FIRST FLOOR DETAILS

LISTED BUILDING CONSENT				kyson		
Rev: B Comments: Amendments as clouded- historic staircase to be reinstated By: KN Date: Nov 25				Studio 28 Scrutton Street London UK EC2A 4RP T: +44(0) 20 7247 2462 E: enquiries@kyson.co.uk W: www.kyson.co.uk		
Project Title: 107 High St, Lindfield, Haywards Heath, West Sussex, RH16 2HR				Project No.: 900-25		
Drawing Title: Corkscrew Winder Staircase - First Floor				Drawing No.: 5008		
Scale: 1:25@A1 1:50@A3				Revision: B		
Date: Apr 25						
Drawn: KN						
Checked: KW

Reflected Ceiling Plan
Scale 1:25@A1
1:50@A3

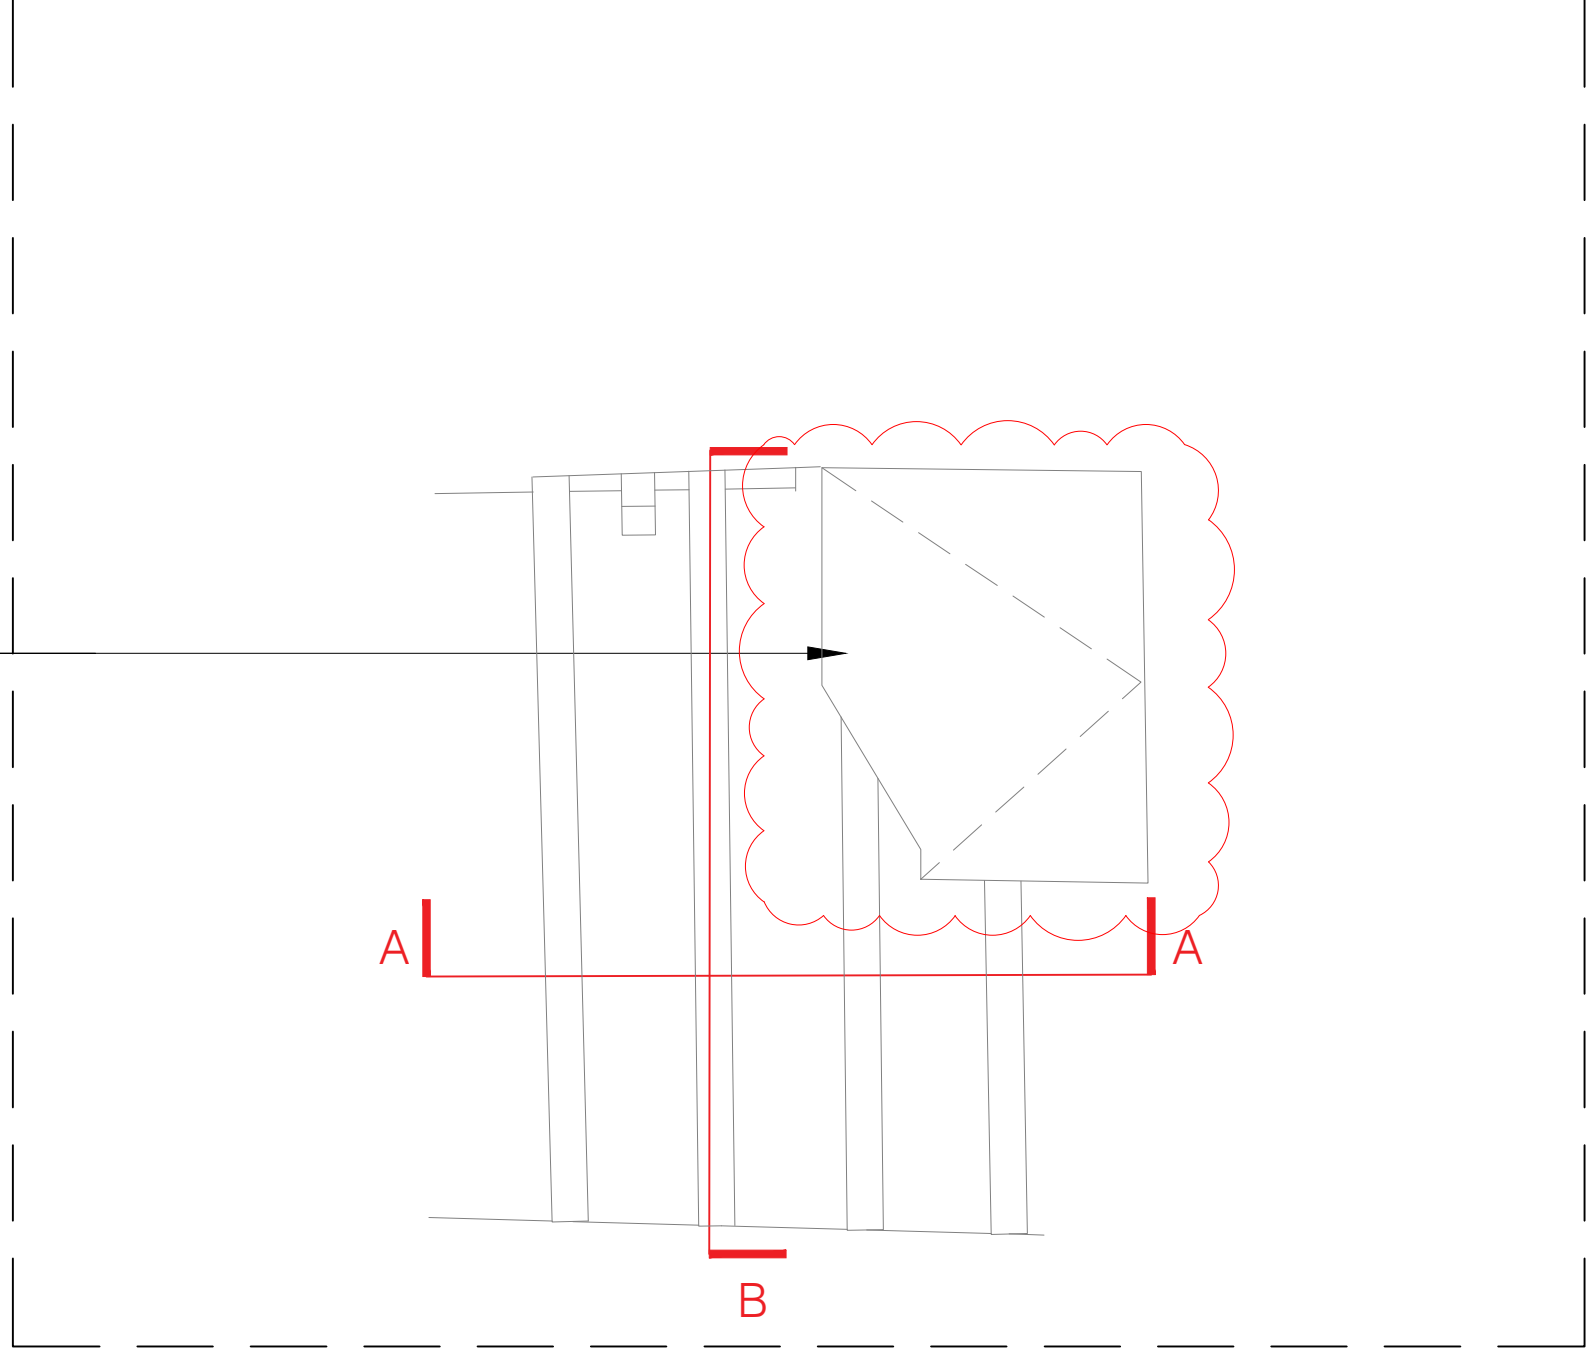
Not original timber joists removed,
historic opening in the ceiling reinstated,
new oak timber hatch introduced

KEY PLAN First Floor Staircase
Scale 1:25@A1
1:50@A3

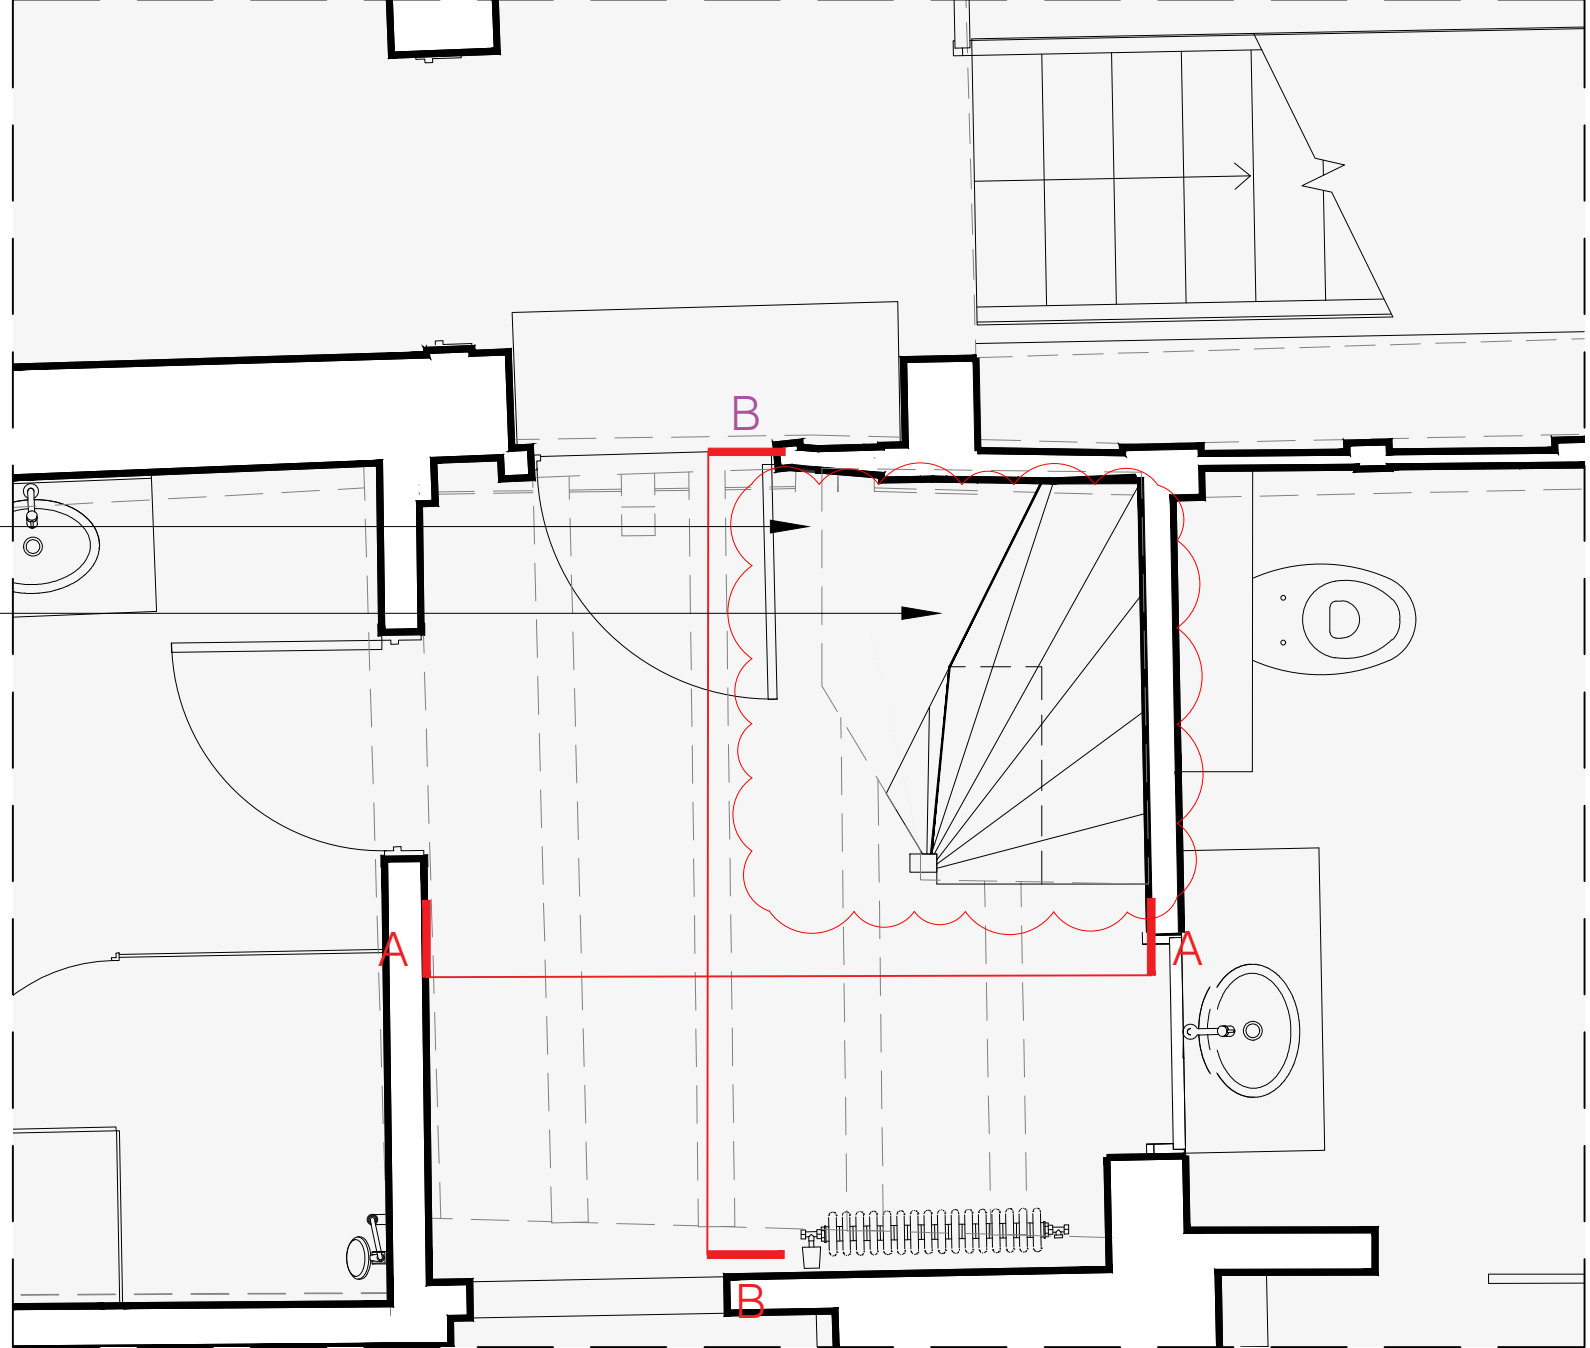
Opening and attic access hatch above
Historic timber staircase reinstated,
salvaged timber steps to be used. Non
original timber enclosure omitted.
